MANATEE COUNTY
FLORIDA

SUBJECT: Invitation for Bid #11-2872DC
North Water Reclamation Facility Expansion 1

ADDENDUM #2

**NWRF Expansion Phase I
County Project No. 6011283
ADDENDUM 2
November 15, 2011**

DATE: JULY 2011	SCALE: 1" = 20'	DRAWING NUMBER: C-0.4.3
MCE PROJ. # 1024-0143	HORIZONTAL: 1" = 20'	REVISION:
DRAWN: BFN	VERTICAL: NA	
DESIGNED: NJS		
CHECKED: DCW		
PROJ. MGR: DCW		
STATUS: ISSUED FOR BID

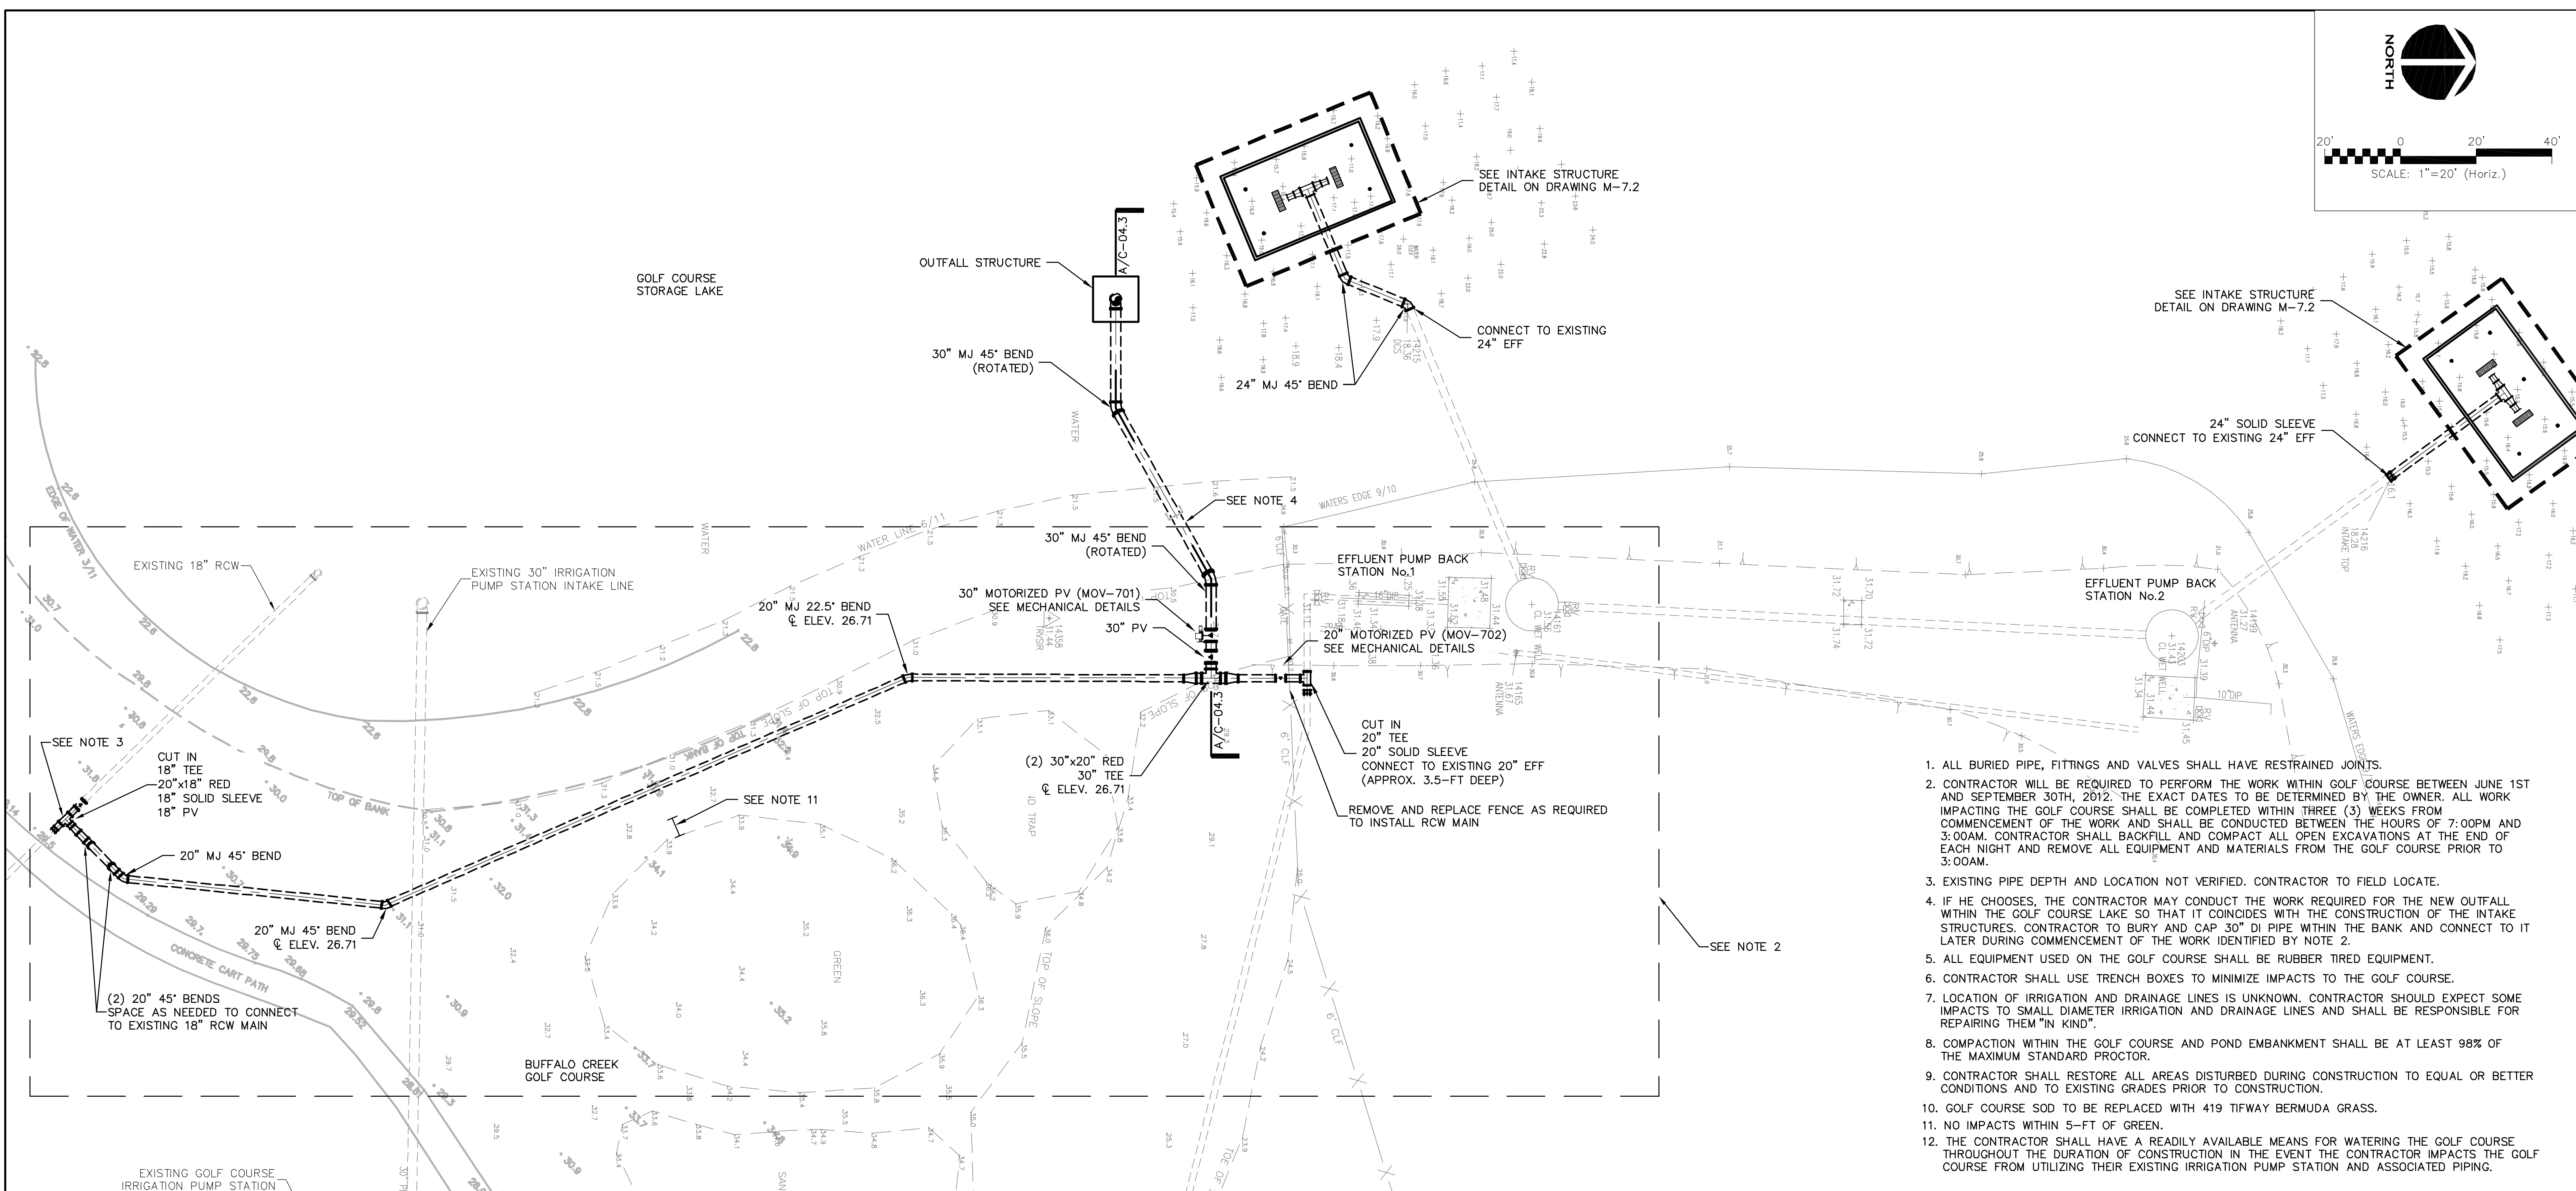
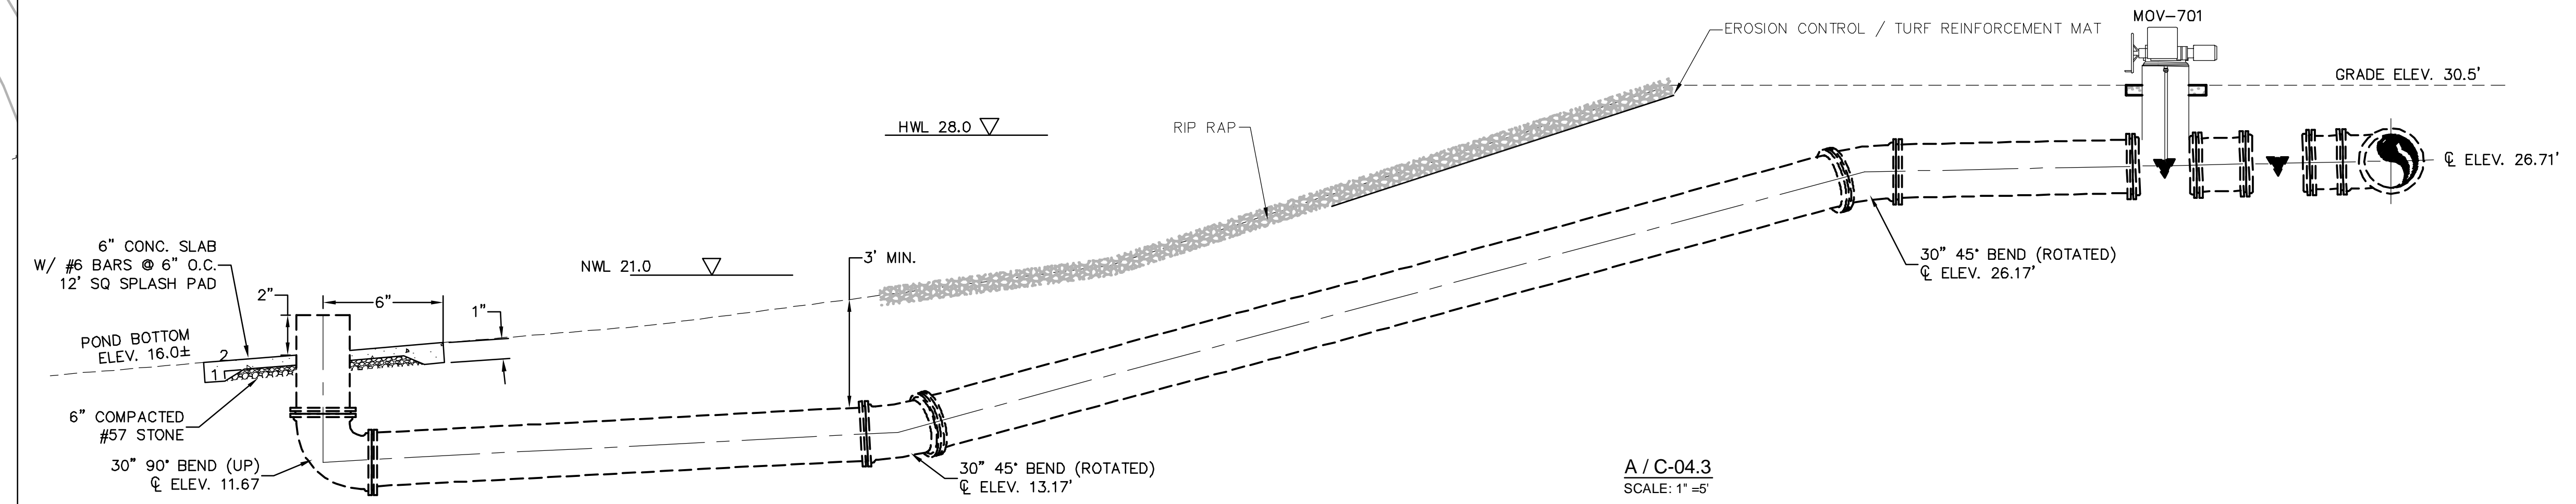
1. Replace Drawing C-0.4.3 with the attached Drawing C-0.4.3 Rev. A.
2. Add the following new Drawings- M-2.1, 2.2 & 2.3; E-2.1, 2.2, 2.3, 2.4 & 2.5; I-2.1

4. Drawing C-0.4.1 show the new 30" D.I.P. effluent line going under an existing vault. A note says that the Contractor shall support & protect vault. This could be very difficult. If this is absolutely necessary, please provide details of this vault including elevations. **The existing vault acts as a cover to shallow buried small diameter pipe. The vault shall be removed prior to construction and reinstalled afterwards.**

5. Drawing D-0.1 shows the contractor to demolish an existing 12" line which appears to pass through the vault mentioned above. Does the vault remain or get demolished? **The vault shall be removed prior to construction and reinstalled afterwards.** Is this the same vault as described in the previous question? **Yes.**

REV. NO.	DESCRIPTION	DATE
A	ADDENDUM NO. 2	11/15/11
